DESIGN <i>CP</i>	DRAWN BY <i>CP</i>	DART AEROSPACE LTD HAWKESBURY, ONTARIO, CANADA	
CHECKED <i>#</i>	APPROVED <i>#</i>	DRAWING NO. D3016	REV. A SHEET 1 OF 3
DATE 01.05.18		TITLE SEAT FRAME ASSEMBLY	SCALE NTS
A	01.05.18	NEW ISSUE

DRAWING NO. D3016	TITLE SEAT FRAME ASSEMBLY	REV. A	DART AEROSPACE LTD ENGINEERING ORDER	D.E.O. NO. D3016-A-1	SHEET NO. SHEET 1 OF 1	SCALE NTS
DRAWN <i>1</i>	CHECKED <i>UP</i>	MFG. APPR. <i>RE</i>	APPROVED <i>WAP</i>	DE APPR. <i>#</i>		
DATE 10.01.29	DATE 10.01.29	DATE 10.01.29	DATE 10.01.29	DATE 10.01.29	DATE 10.01.29

PURPOSE:

TO REVISE D3016-11 SADDLE'S HOLE SIZES

D3016-11 SADDLE

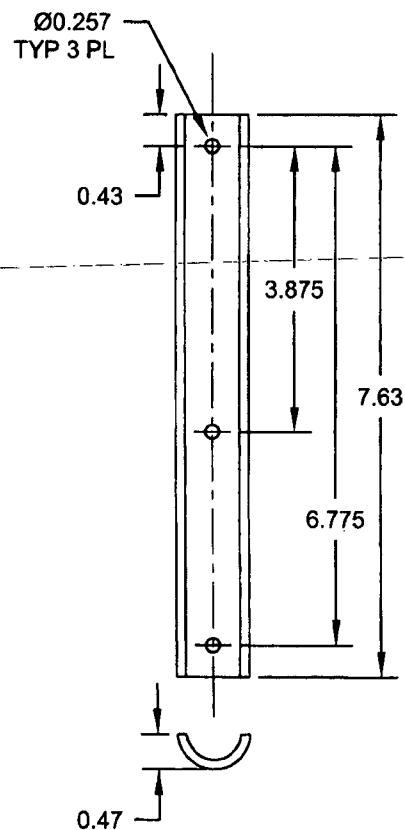
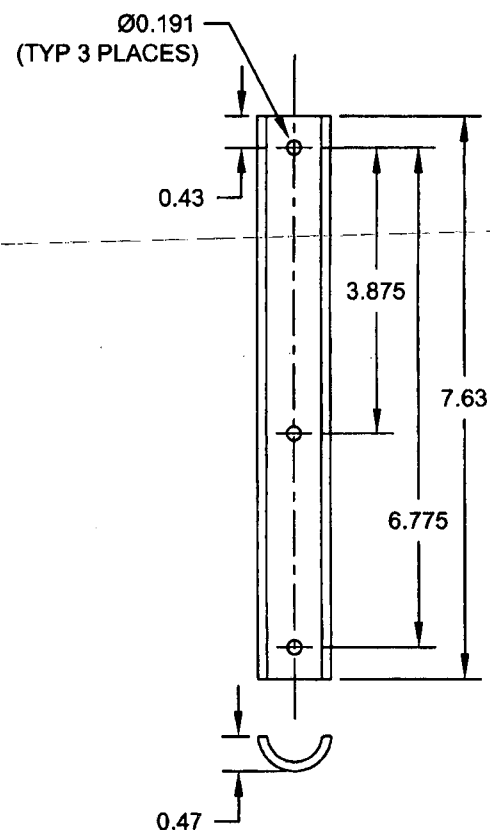
DETAIL D3016-11 SADDLE (SHEET 3): Ø0.257 TYP 3 PL WAS Ø0.191 (TYP 3 PLACES) AS SHOWN:
